Clinch River Nuclear Site  
NRC Docket No. 52-047

Subject: Submittal of Supplemental Information Associated with Hydrologic Engineering in Support of the Clinch River Nuclear Site Early Site Permit Application

Supplemental Information Regarding Site Safety Analysis Report Section 2.4,  
“Hydrologic Engineering”

Figure 2.4.3-17. Unit Hydrographs, Sub-basins 7, 8, 16-18, & 23-24 (Sheet 5 of 8)

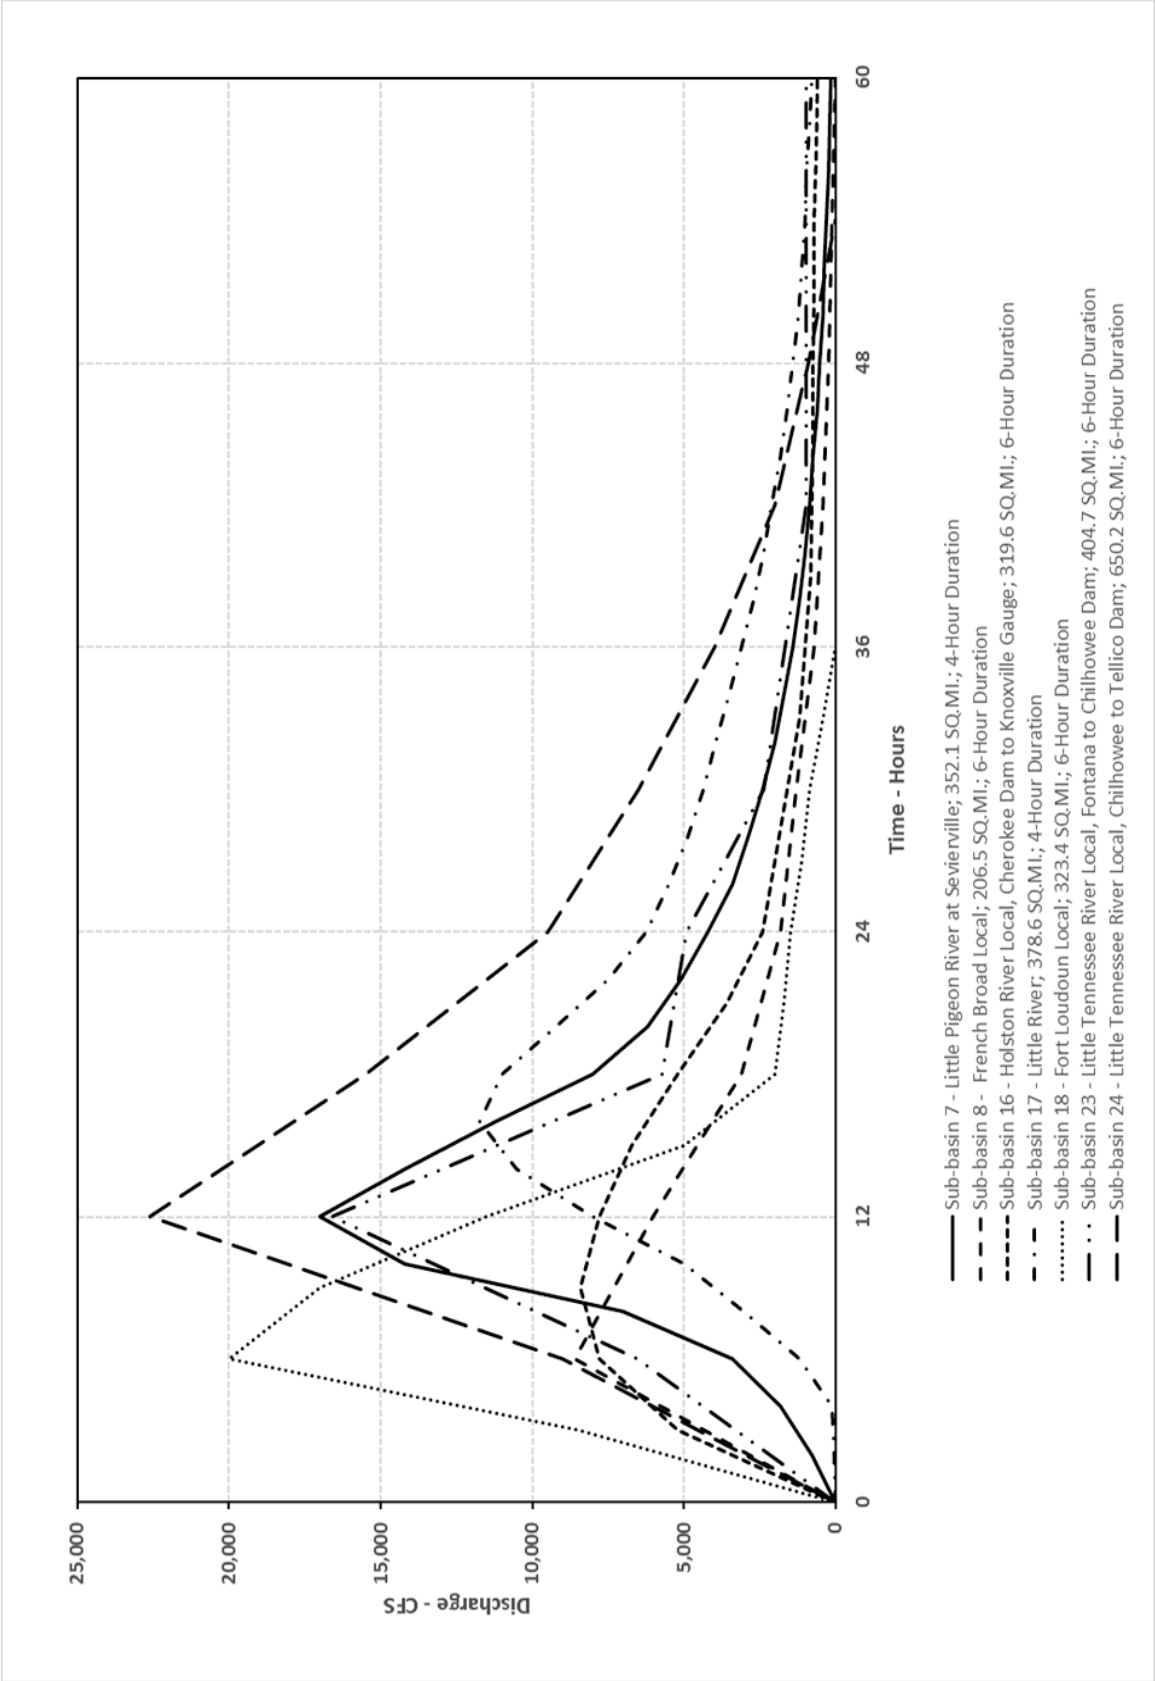
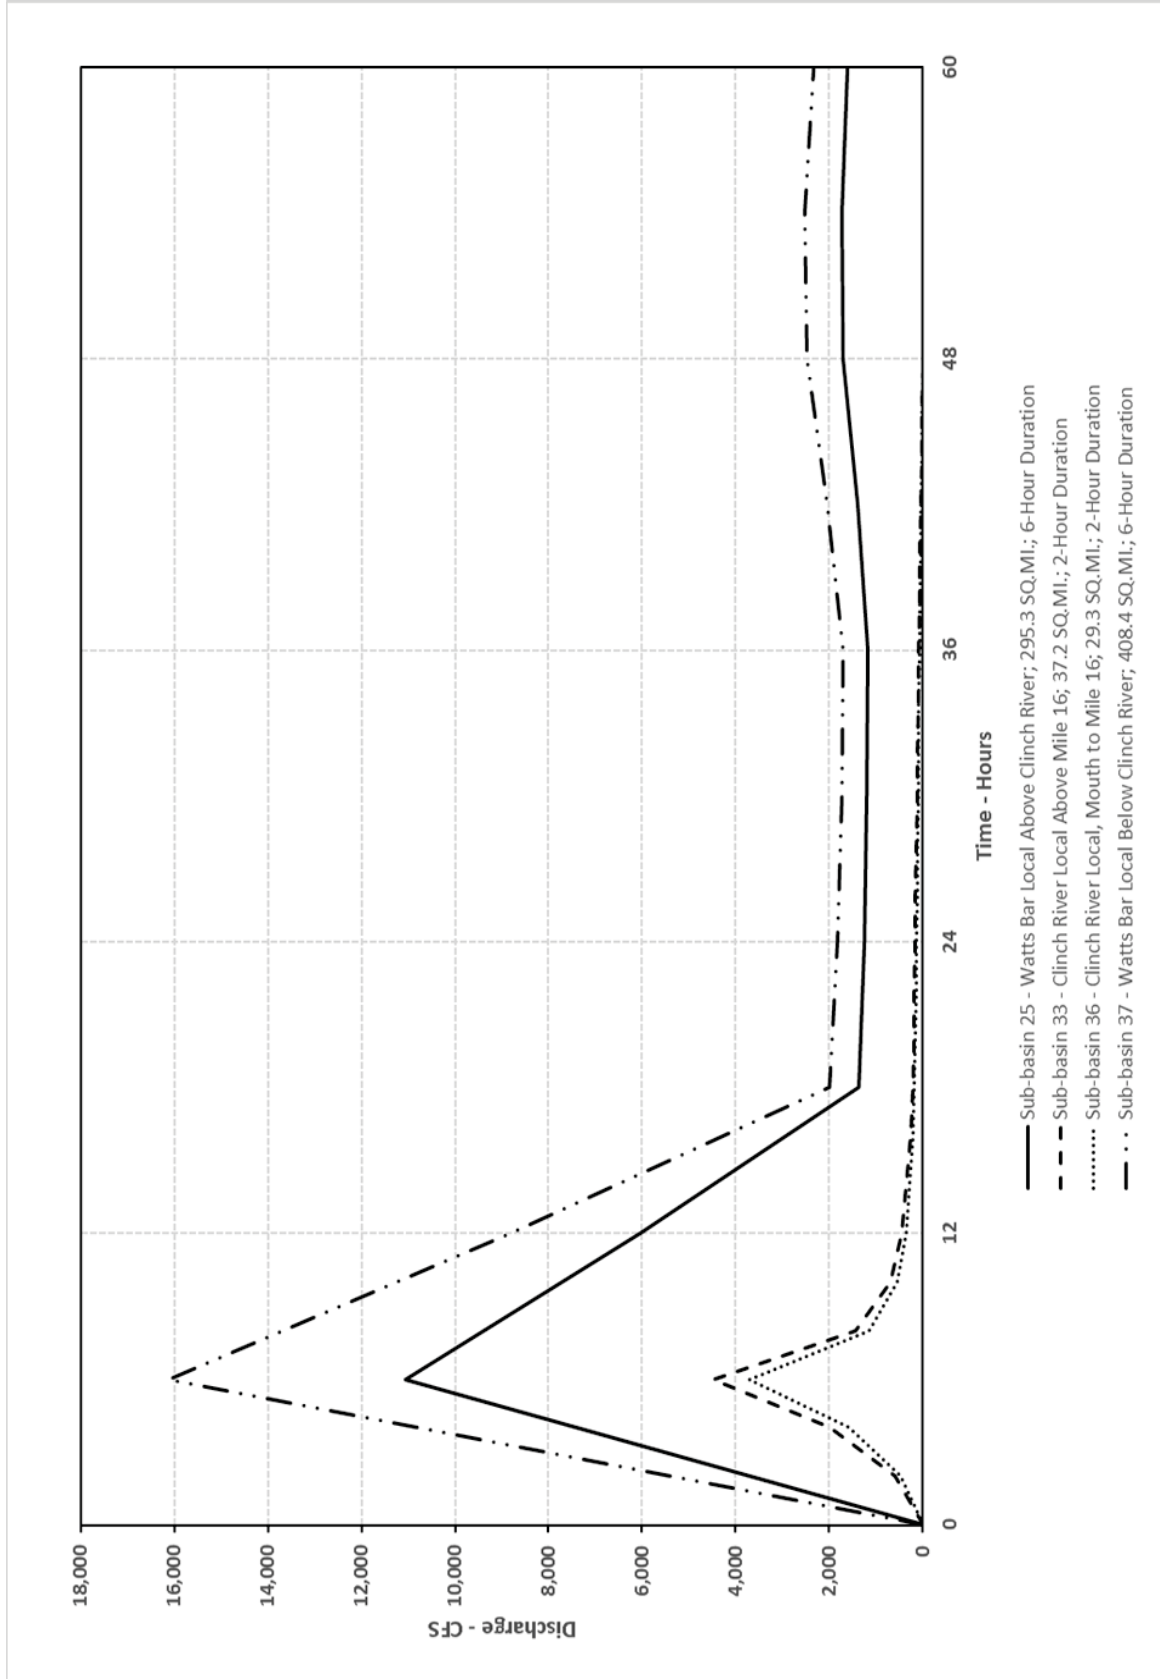
A discussion of how the Unit Hydrographs (UHs) were developed, including validation of the UH's is being added, under a subheading titled "Unit Hydrograph Development and Validation," to SSAR Subsection 2.4.3.4.1, "Runoff Model." Validated unit hydrograph figures and reference to those figures are also being added with this revision. In addition, a discussion of how the inflows were determined for the 1973/2003 storms used in the calibration is being added to SSAR Subsection 2.4.3.4.3, "Stream Course Model Geometry Development and Calibration." For these changes, see the markup provided in SSAR Subsection 2.4.3.4.1, subheading "Unit Hydrograph Development and Validation," addition of new Figures 2.4.3-17, Sheets 1 through 8, and Figures 2.4.3-18, 2.4.3-19, and 2.4.3-20, and SSAR Subsection 2.4.3.4.3, the eighth paragraph, in Attachment 3.

Figure 2.4.3-18. NID Inflow Hydrograph, Norris Reservoir

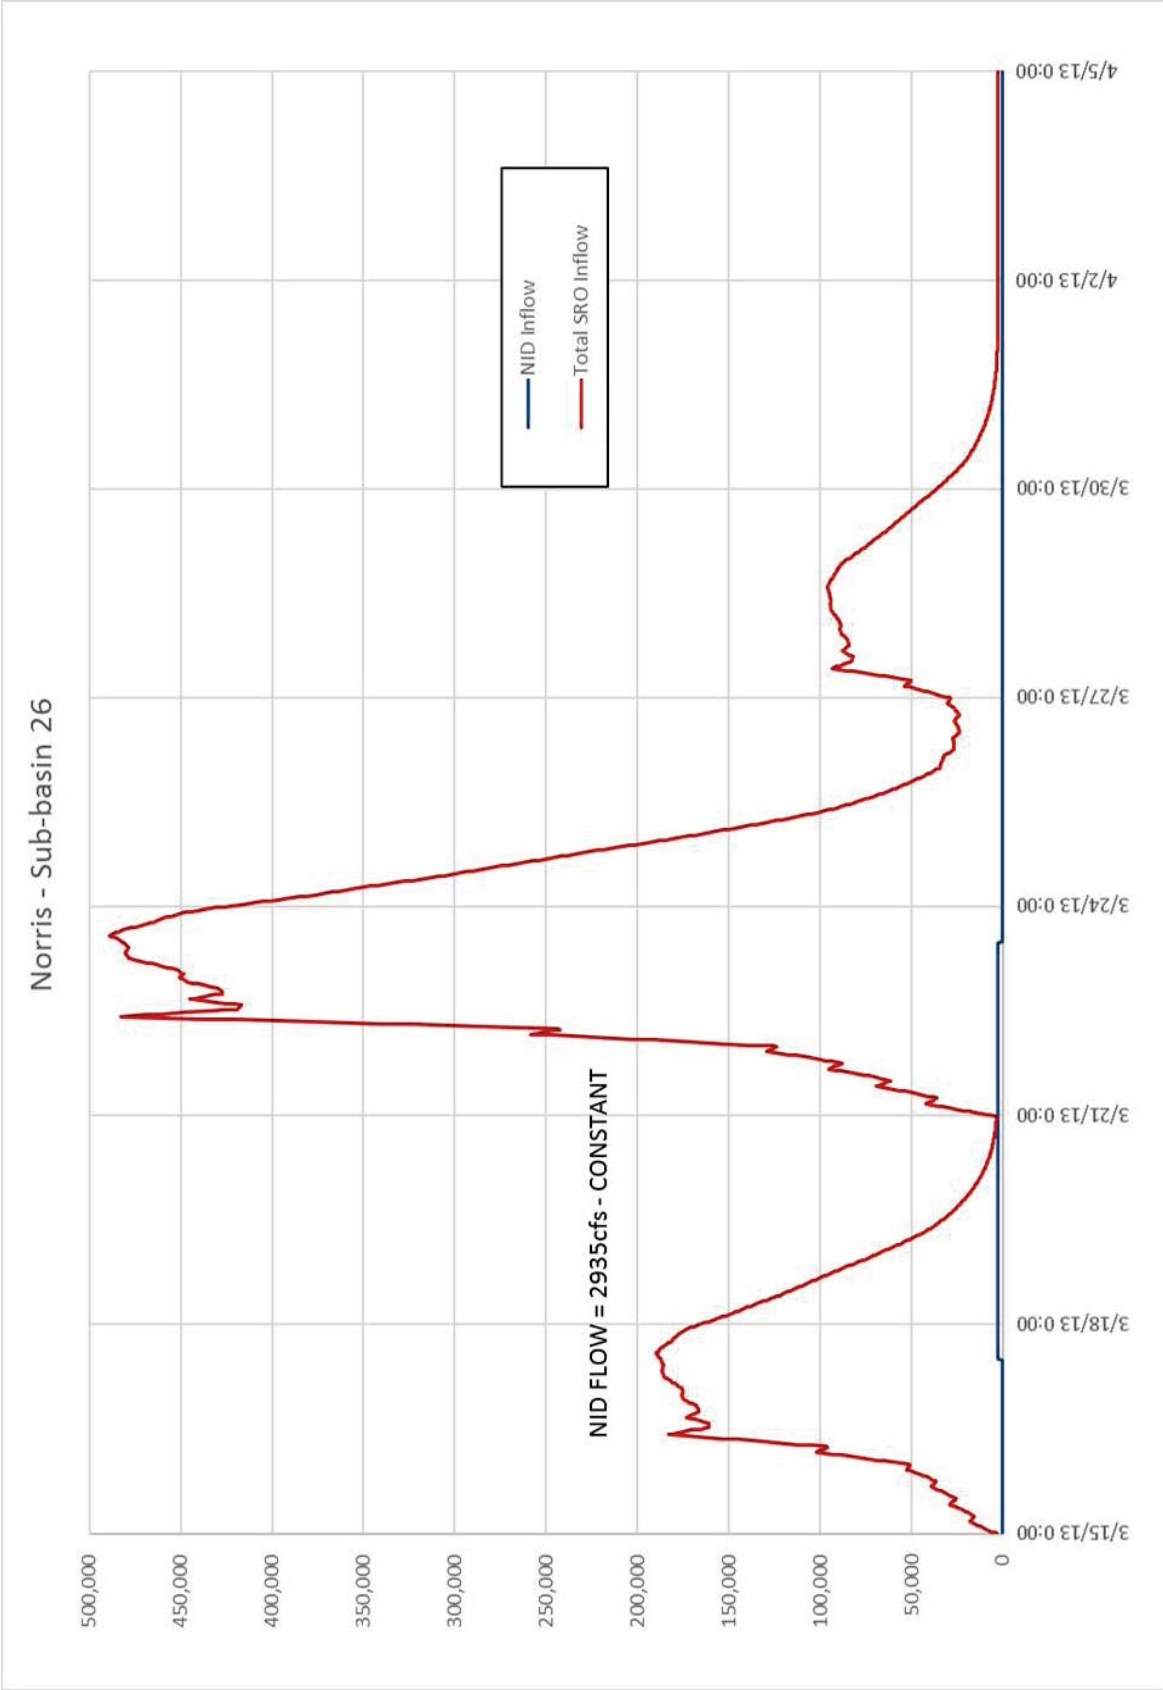
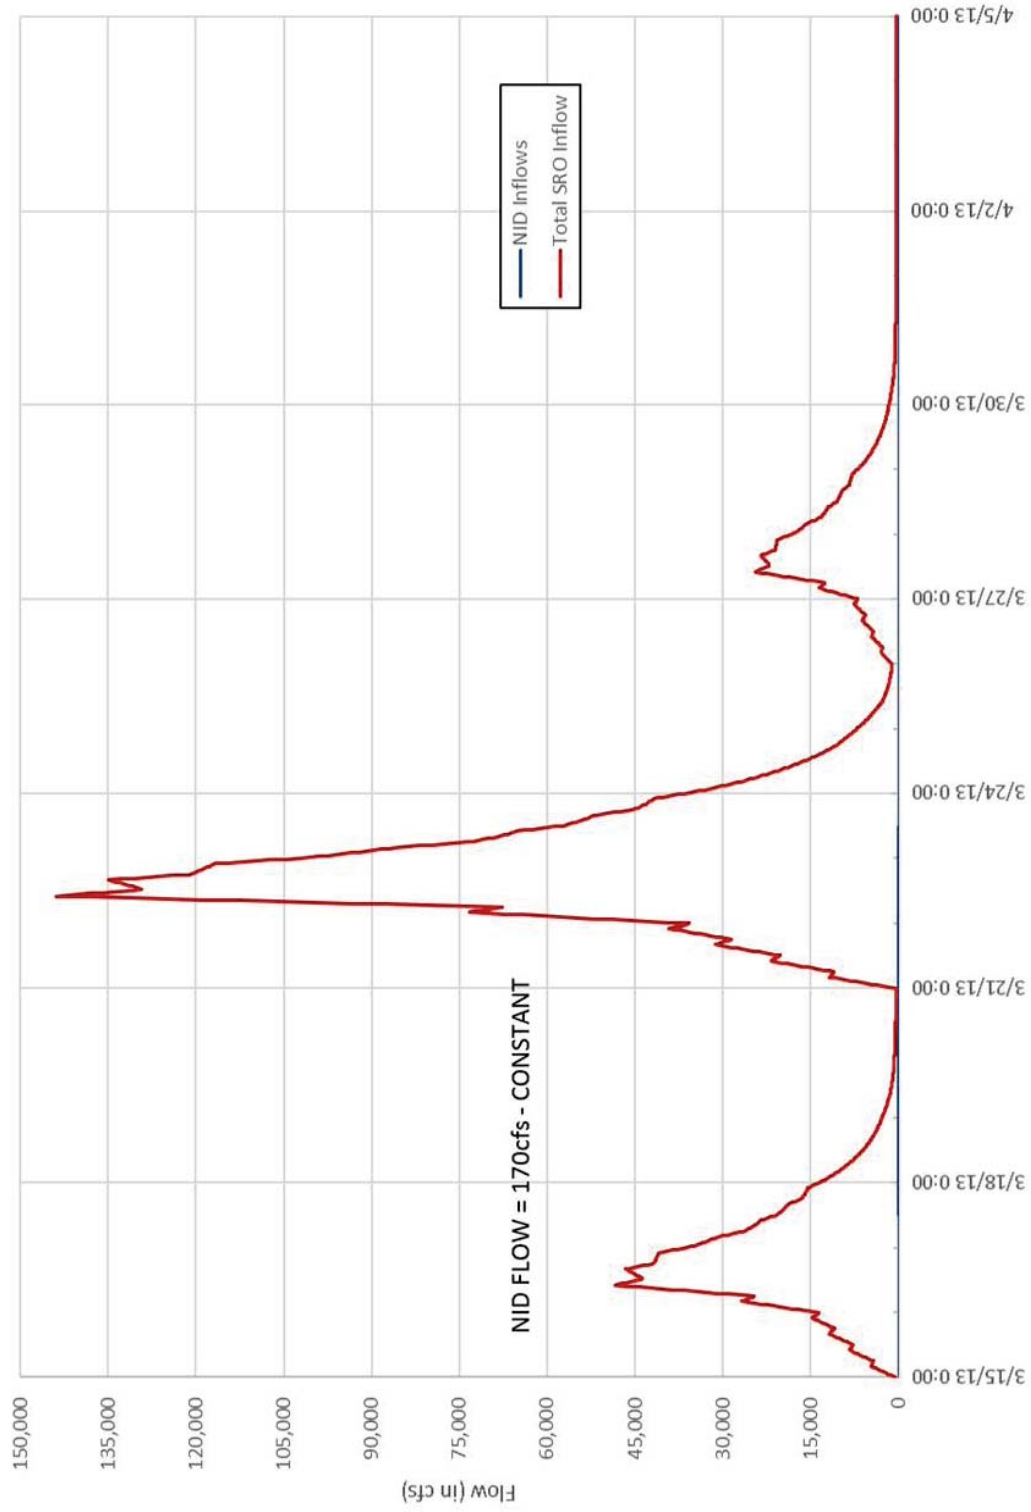
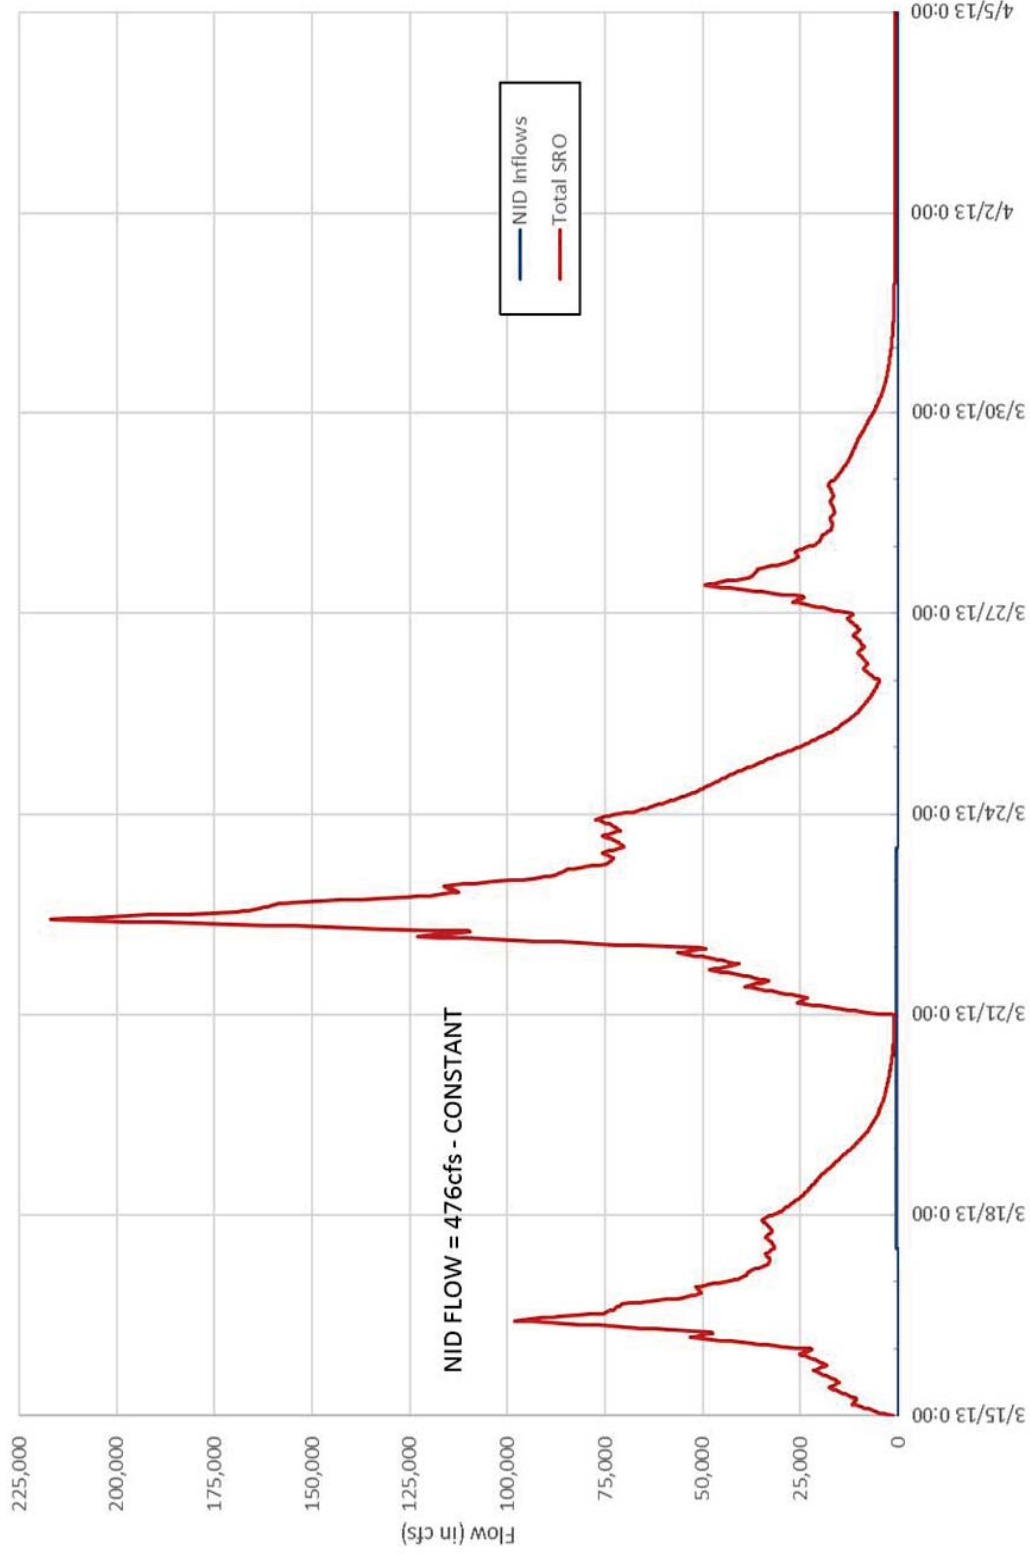
A clarification of how the storage volume from NID dams was used to develop inflow hydrographs is being added to SSAR Subsection 2.4.3.4.1, "Runoff Model," under the new subheading "National Inventory of Dams (NID) Considerations." See the markup provided in SSAR Subsection 2.4.3.4.1, under the new subheading "National Inventory of Dams (NIS) Considerations," in Attachment 3.

DEPARTMENT OF TRANSPORTATION  
 BRIDGE NO. 1  
 WIDENING OF  
 BRIDGE 110 NO. 733R0580003  
 STATION 10+461.000  
 ROANE COUNTY  
 1999

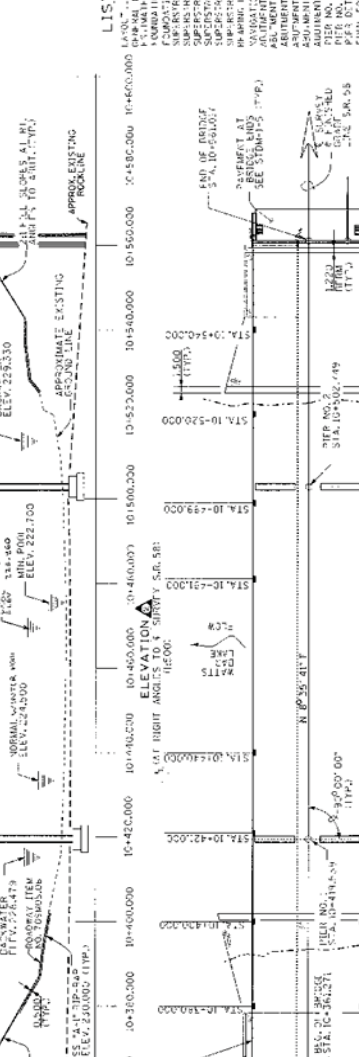
A discussion of the Highway 58 bridge sensitivity analysis and the results/conclusions is being added to SSAR Subsection 2.4.3.4.3, "Stream Course Model Geometry Development and Calibration." In addition, a figure depicting the Highway 58 bridge profile is being added to the SSAR and reference to the Figure is being included in the SSAR Subsection 2.4.3.4.3 discussion. See the markup provided in SSAR Subsection 2.4.3.4.3, fourth paragraph, and addition of new Figure 2.4.3-21, "Highway 58 Bridge Profile," in Attachment 3.

The Highway 58 bridge (Figure 2.4.3-21) near Clinch River Mile (CRM) 14 was not included in the HEC-RAS geometry because the impact was considered to not be significant. A sensitivity analysis was performed by inserting additional cross-sections at the Highway 58 bridge location based upon bridge drawing obtained from the Tennessee Department of Transportation and surrounding topography. The sensitivity analysis indicated a negligible impact (less than 0.1 ft) at the CRN Site.
